To: T10 Technical Committee
 From: Rob Elliott, HP (elliott@hp.com)
 Date: 31 August 2006
 Subject: 05-381r4 SAS-2 Multiplexing

Revision 4 (31 August 2006) Incorporated comments from July 2006 SAS protocol WG, including adding a REASON field to the IDENTIFY address frame. Included changes to SL_IRM state machines. Based on feedback from the SCSI Trade Association, dropped support for four-way multiplexing.

Figure 3 — Phy class diagram

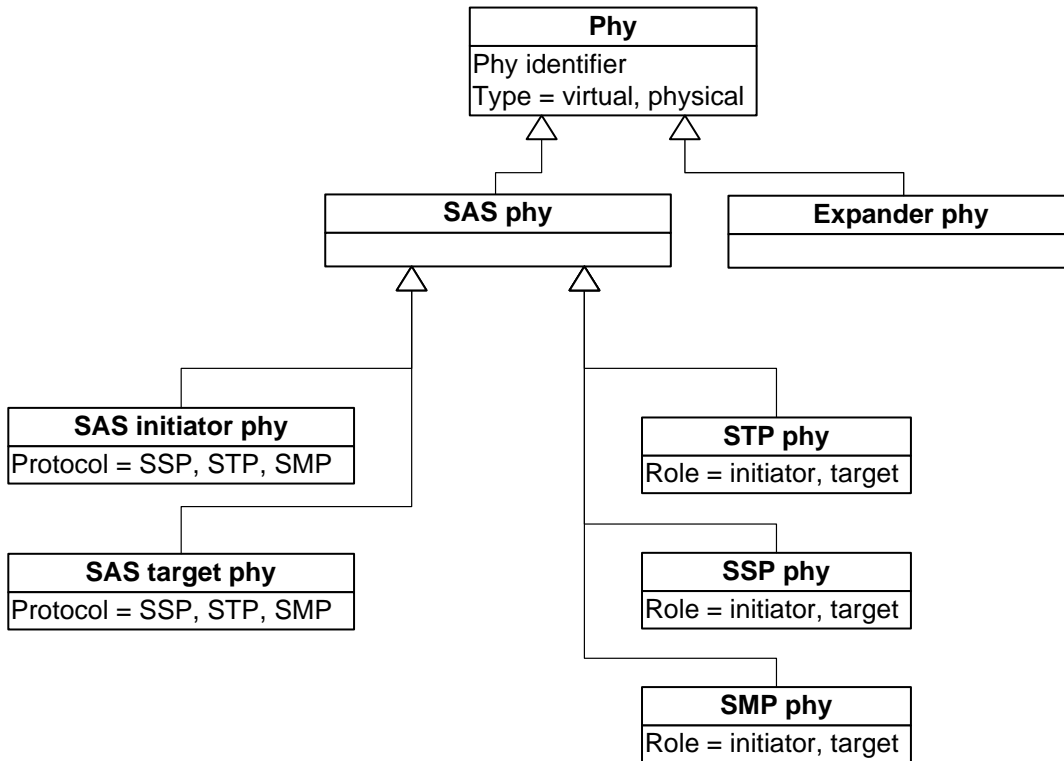
Editor's Note 3: Logical phys (SAS logical phys and expander logical phys) need to be included in the UML model.
